Docket Item # 9
BAR CASE # 2009-0099

BAR Meeting
June 3, 2009

ISSUE: Addition
APPLICANT: Lewis and Associates LTD by Ray Lewis
LOCATION: 413 South Fairfax Street
ZONE: RM/Residential

STAFF RECOMMENDATION: Staff recommends deferral of the application.

Figure 1: Plat showing addition footprint.

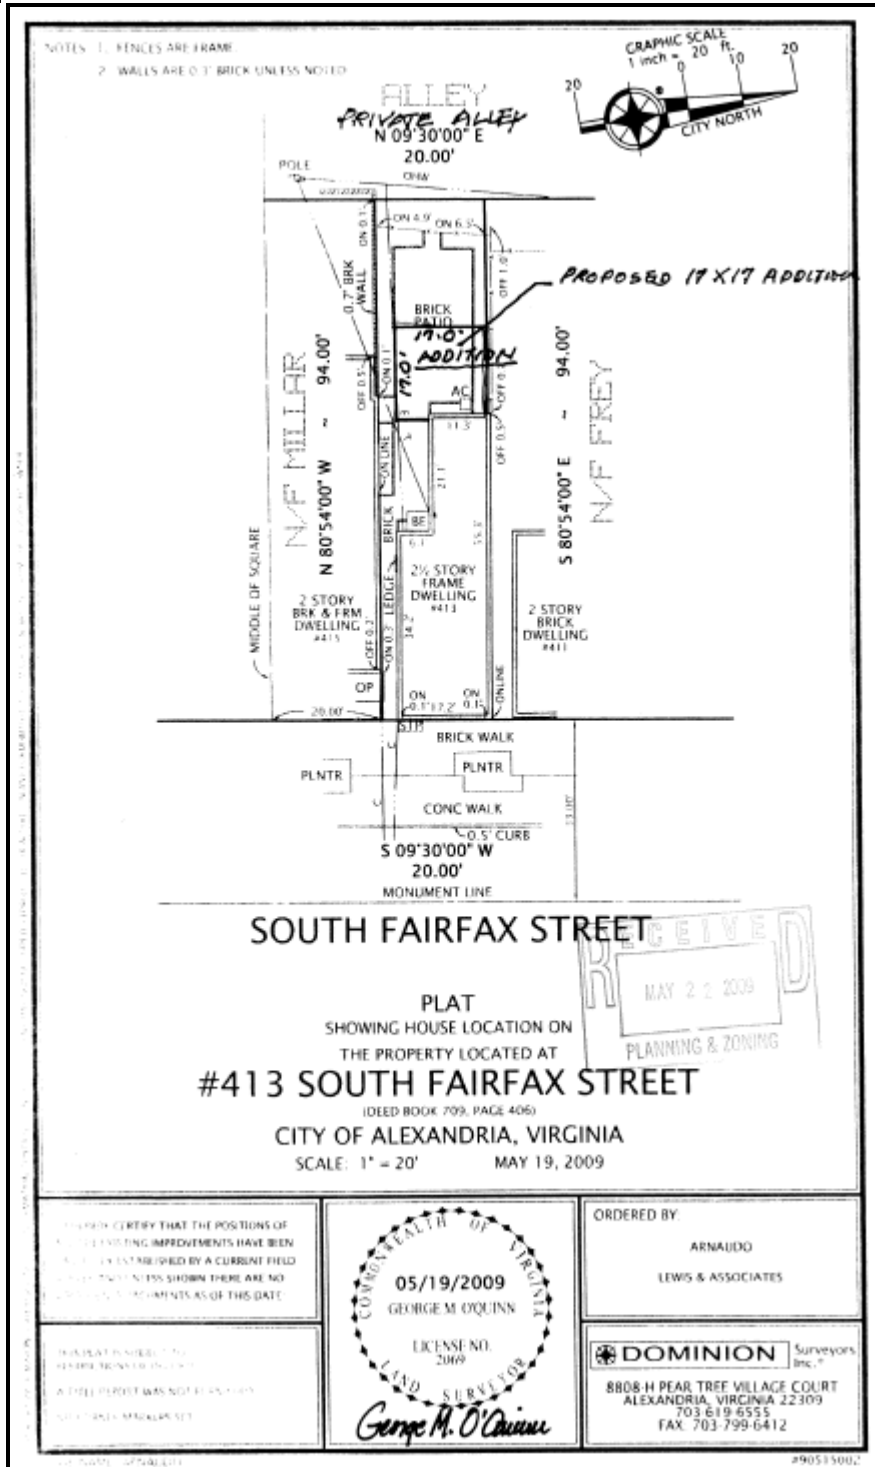
The proposed addition complies with the RM requirements of the Zoning Ordinance. In order to comply with the required open space for the RM zone the existing (and any future) HVAC equipment may not be located in required open space.

Figure 6: Proposed north and south elevations.

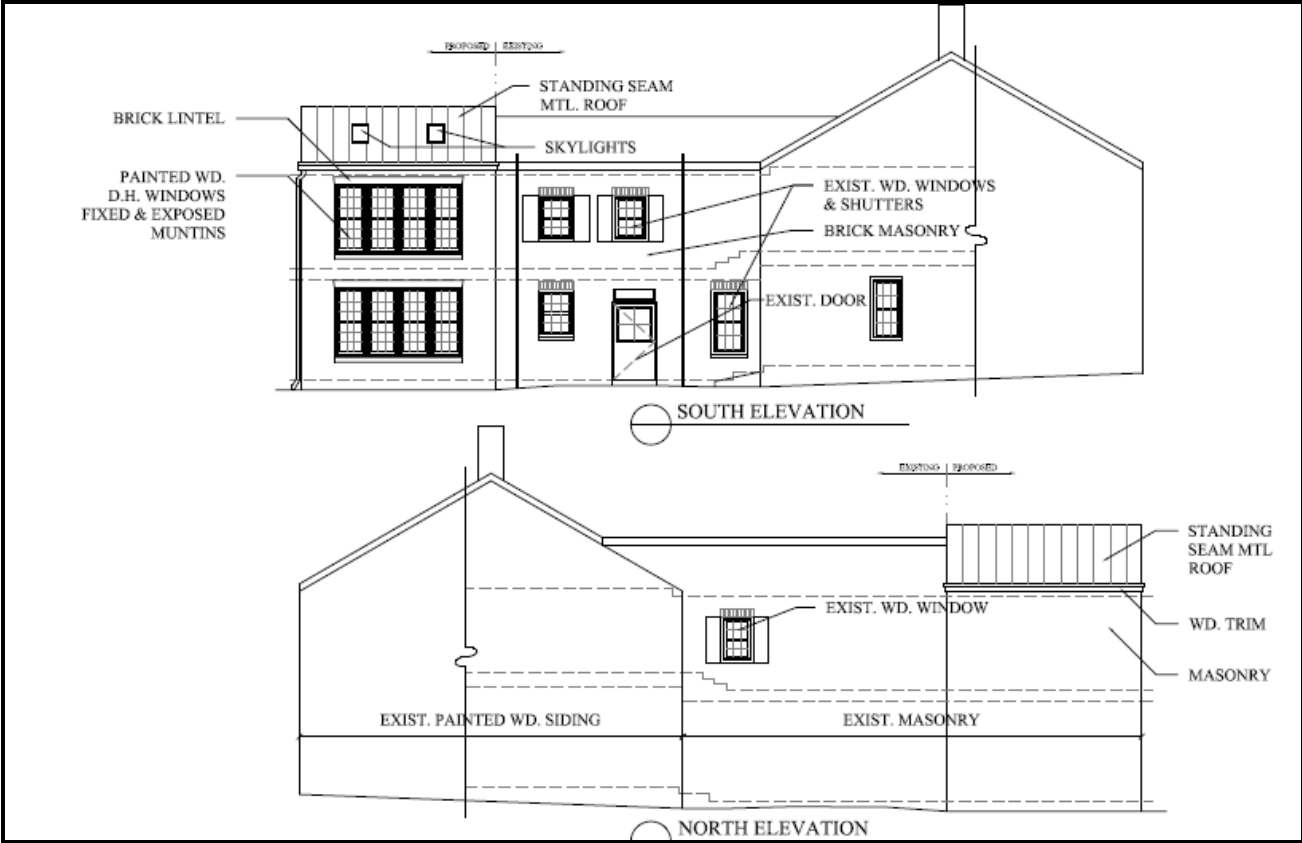
Staff met with the applicant and expressed concern about the form and fenestration of the proposed addition. The addition, while designed with a traditional gable roof, does not easily relate to the rear ell to which it is being added. The slope of the gable roof creates an awkward area on the north where a triangle of the ell will be exposed. While it is appropriate, and even encouraged, to differentiate new construction from historic fabric, Staff believes that the proposed gable roof addition may not be the most appropriate form. The Board recently approved a rear addition to a house with a similar rear ell (208 North Fairfax Street) where the first proposal was for a gable roofed addition which created too much mass at the rear of the house. At the suggestion of Staff, the applicant revised the addition to have a shed roof perpendicular to the ell; this may be a viable solution in this particular case.

The *Design Guidelines* recommend that “the fenestration pattern, i.e. the relationship of solid to void, such as windows, doors, and walls, should be compatible with the fenestration pattern on the existing structure.” Staff believes that the addition’s fenestration, in particular the second story glazing on the rear elevation, is inappropriate and should be changed to more closely reflect the historic building’s fenestration pattern. In addition, the windows on the south elevation do not comply with Code Administration’s recommendation per the building code that openings in exterior walls between 3 and 5 feet not exceed 25% of the area of the entire wall surface. The applicant has stated that a waiver will be obtained from Code Administration to allow fire rated windows on the south elevation.

While Staff recognizes that the new addition will be limited in its visibility from any public views, Staff believes that revisions to the design are possible in order to improve its compatibility and appropriateness to the original historic house, namely addressing the issues of the roof form and the fenestration pattern. Therefore, Staff recommends that the application be deferred to address the issues raised in the staff report.
